Field Safety Corrective Action of Philips Allura Xper R7.6- R8.1 system from Philips Medical Systems Nederland B.V.

## URGENT Field Safety Notice

### Philips Allura Xper R7.6- R8.1 systems

Delay of installation of the Lifetime Extension (LTE) kit in Allura Xper R7.6-R8.1 systems may lead to a broken propeller motor clamping bolt and a broken X-ray tube locking bolt.

Figure 1: Clamping bolt of the C-arm propeller drive

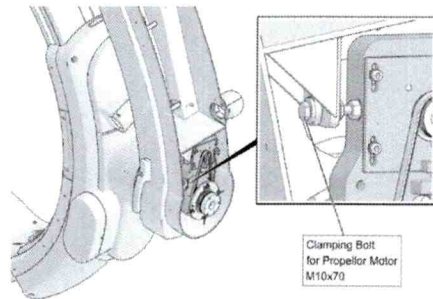
Philips has identified potential safety issues with delayed LTE kit installations for Allura R7.6-R8.1 systems exceeding 10 years of life. The kit includes a propeller motor clamping bolt (see Figure 1) and the X-ray tube locking bolt (see Figure 2). If one of these bolts breaks, part of the system will not function as expected.

If the installation of the LTE kit is delayed, breakage of the propeller motor clamping bolt and/or the X-ray tube locking bolt may be expected. If this occurs,

Philips will contact all affected customers to arrange for a Field Service Engineer visit to install a Lifetime Extension Kit (reference FCO72200598). As of the date of this Urgent Field Safety Notice, Philips expects the solution to be available by Q1 2025.

Figure 2: Locking bolt of the X-ray tube

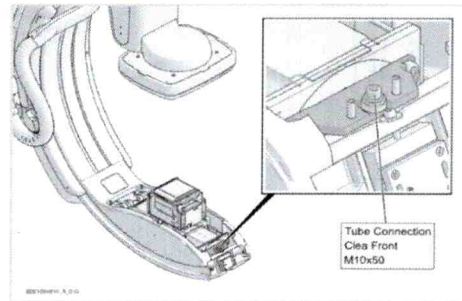
A broken X-ray tube locking bolt could cause a black area to appear on the X-ray image, which may obscure the area of interest. This may require repeat imaging (up to 1 or 2 additional X-ray images or 3D scans), leading to additional radiation exposure. However, this additional radiation is not expected to exceed the thresholds for tissue reactions set by the International Commission on Radiological Protection (ICRP) for the risk of illness or injury.

Figure 3: Erratic movements of C-arm (red circle) due to broken propeller motor clamping bolt.

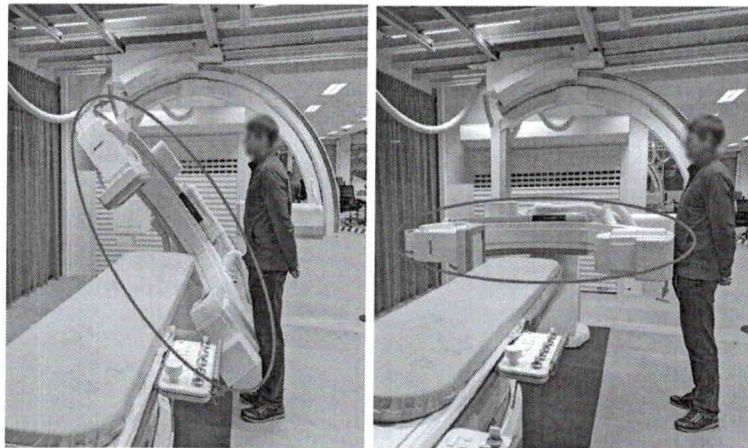
- The broken propeller motor clamping bolt may cause erratic C-arm movements, and potentially colliding with patients or bystanders (see Figure 3). These unbalanced movements may also cause the system to falsely detect a collision, consequently blocking motorized C-arm movements.
- The broken X-ray tube locking bolt may cause the tube to hit the cover, causing unexpected noise and the appearance of a black area (maximum up to 25%) on the X-ray image. Consequently, the area of interest in the X-ray image may be obscured, leading to the need for an additional scan.

A broken propeller motor clamping bolt could cause erratic C-arm movements, potentially resulting in the tube or the detector hitting staff or patients, leading to minor physical injuries (Example: hematoma/bruises, scratches, small cuts, or skin abrasions). Additionally, these erratic movements may trigger false collision detections, blocking all C-arm motorized movements and potentially delaying diagnosis or treatment.
